Proposal for supplement 4 to the 01 series of amendments to Regulation No. 94

I. Proposal

Paragraph 6.2.1., amend to read:

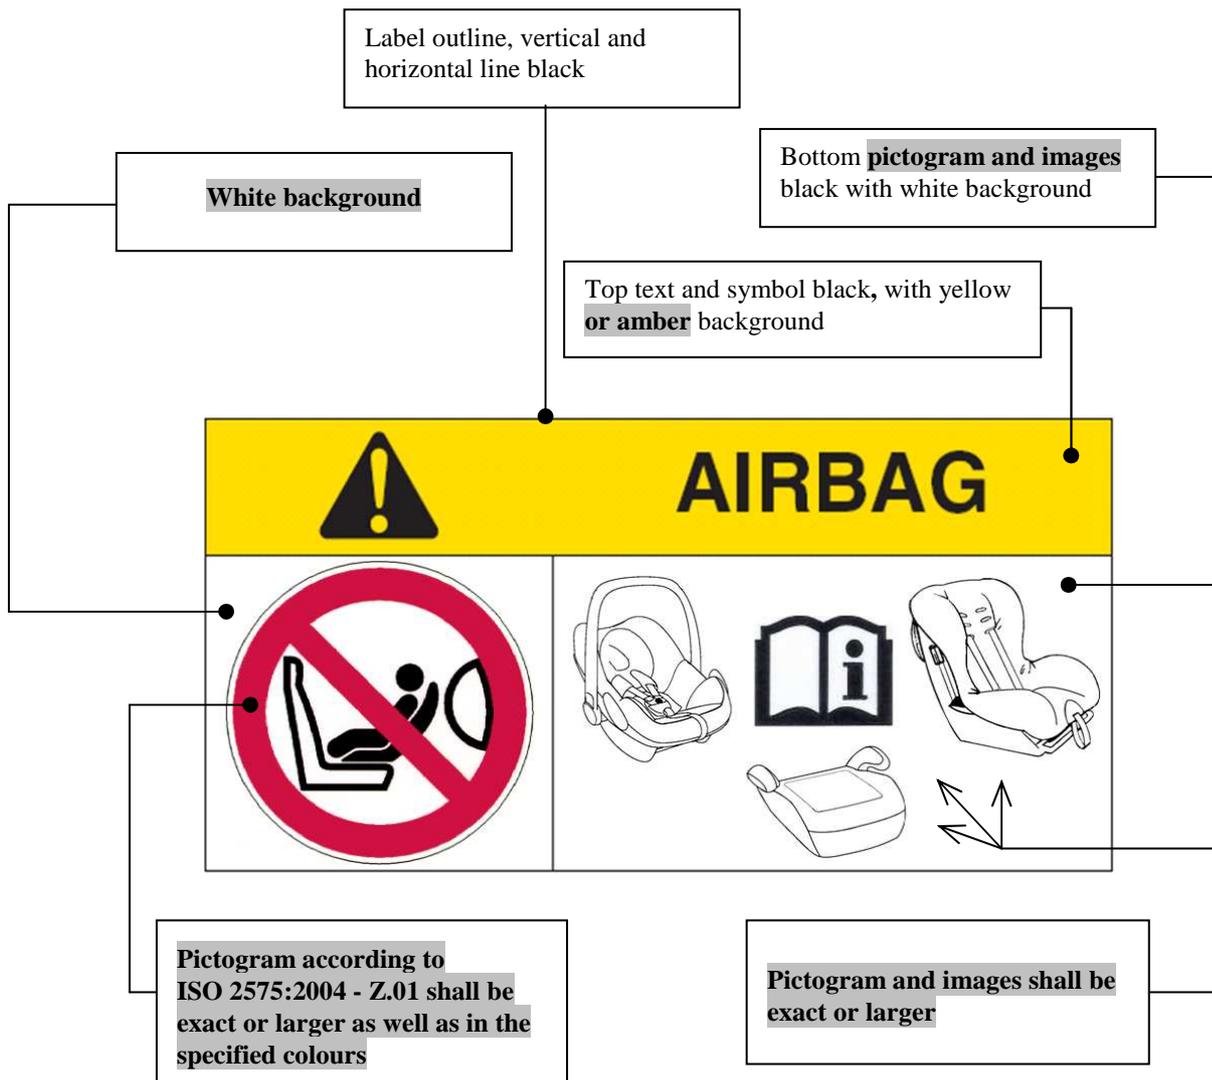
"6.2.1. As a minimum, this information shall consist of a label containing **clear warning pictograms**, ~~an example of which is~~ as indicated below.

The overall dimensions shall be ~~80 x 40 at least~~ 120 x 60 mm or the equivalent area, ~~as a minimum.~~

The label shown above may be adapted in such a way that the layout differs from the example above; however, the ~~text~~ content shall meet the above prescriptions."

The size of the warning label should remain at least 120 x 60 mm, as the size proposed in working document ECE/TRANS/WP.29/GRSP/2010/12 is not sufficient.

The images of the different kinds of child and booster seats are included to make the person unambiguously aware that this warning concerns Child Restrain Systems in general and indicates clearly to refer to the instruction manual. In the original proposal, it is not clear enough under what circumstances the instruction manual should be referenced by the vehicle operator.

The exact airbag warning pictogram as published under ISO 2575:2004 – Z.01 should be used, as this pictogram seems to be understood very clearly, particularly that it concerns children, placed in a rearward facing child seat, on a front seat with the presence of an airbag. Especially the latter is rather remarkable and may be contributed to the common assumption that an airbag is expected to be white (as it appears in the pictogram).
